Addendum Number Three

To The Drawings and Specifications for
Hadley Middle School – Wichita, Kansas
Wichita Unified School District # 259

Issued: April 27, 2010

HANNEY & ASSOCIATES ARCHITECTS

4.3 Sheet E2.2 "PARTIAL PLAN - POWER"

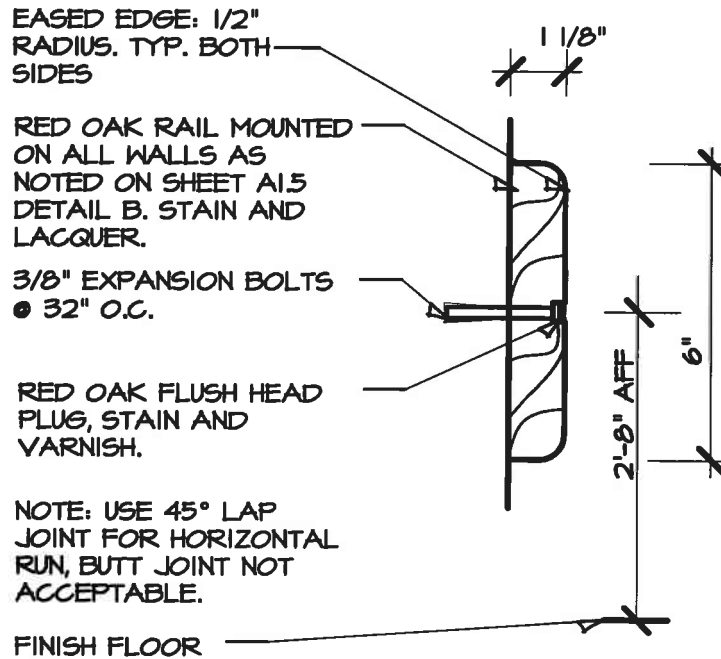
Area 109 Kitchen All 15A and 20A single pole devices shall be GFCI protected. Change all normal duplex receptacles To GFCI type duplex receptacles. IG cash register outlets, "K12" via GFCI circuit breaker in panel LK.

REVISION TO SHEET A7.6

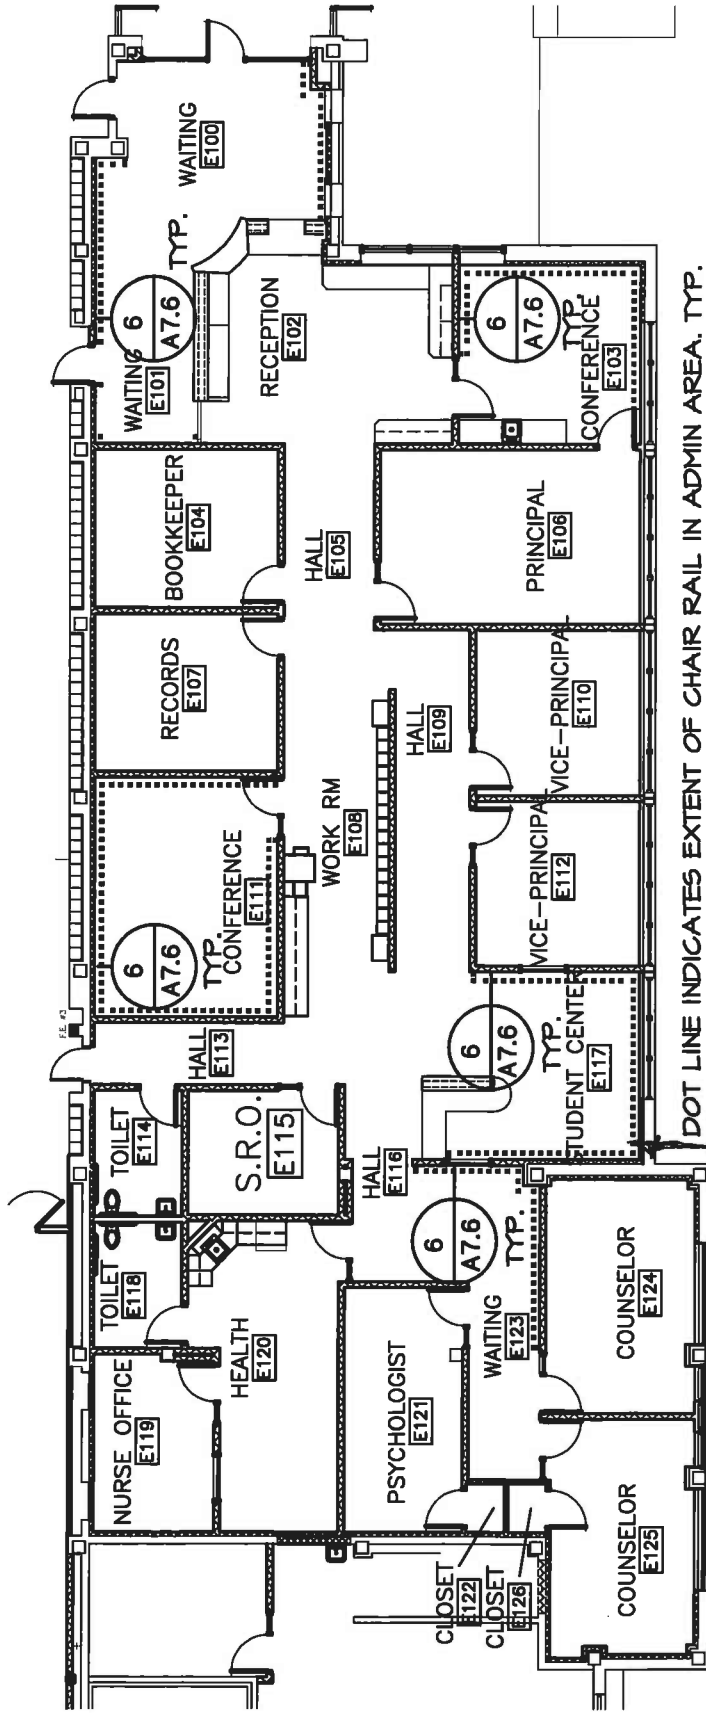
Detail 6 shall be added to this sheet. The detail shall be a wood chair rail detail. The sheet is not being reissued, the detail is accompanies this addendum.

R1

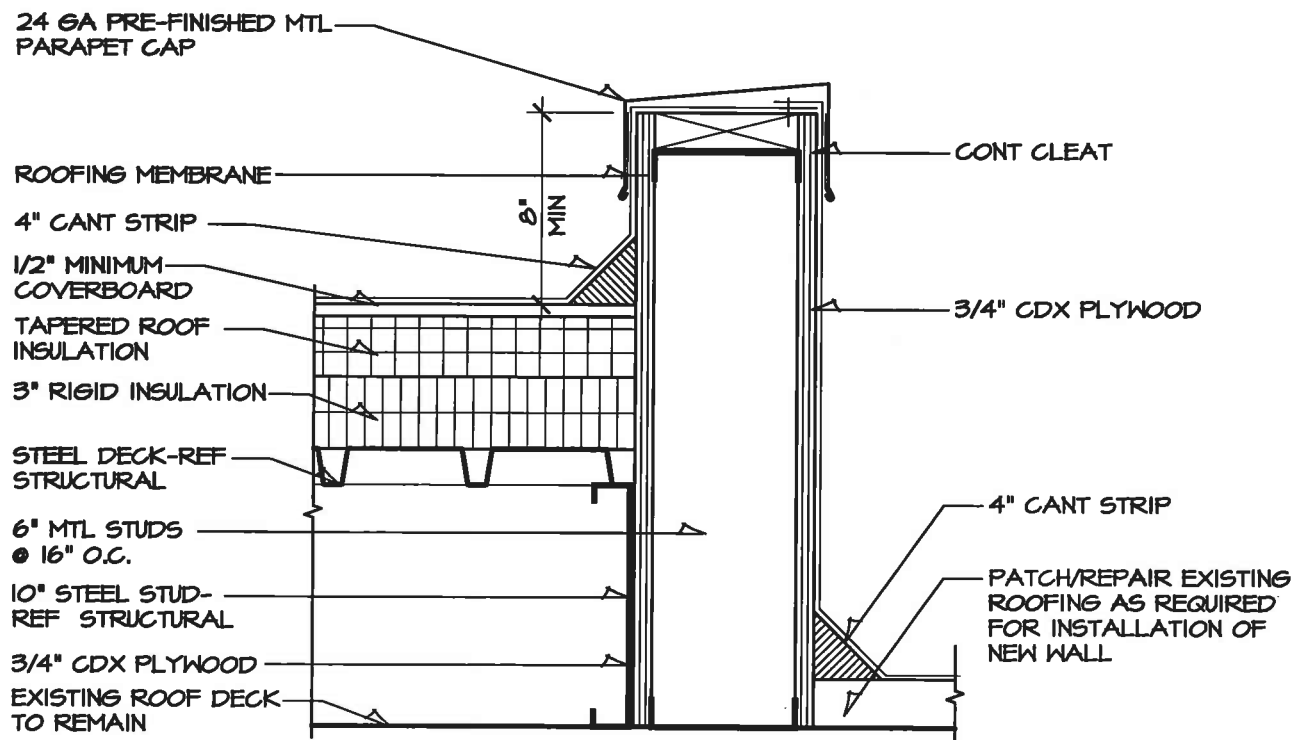
- 3.8 Sheet A2.0
- Detail "A" Lower Roof Plan- The transition wall between Roof 6 and Roof 9 shall be constructed per detail "B" on attached sheet "R1"
- 3.9 Sheet A2.1

- 3.15 Sheet A5.5
The roof expansion joint shall be constructed per detail "A" on attached sheet R1.
- 3.16 Sheet A5.8
Wall Section "B"- The roof expansion joint shall be similar to detail "A" on attached sheet R1.
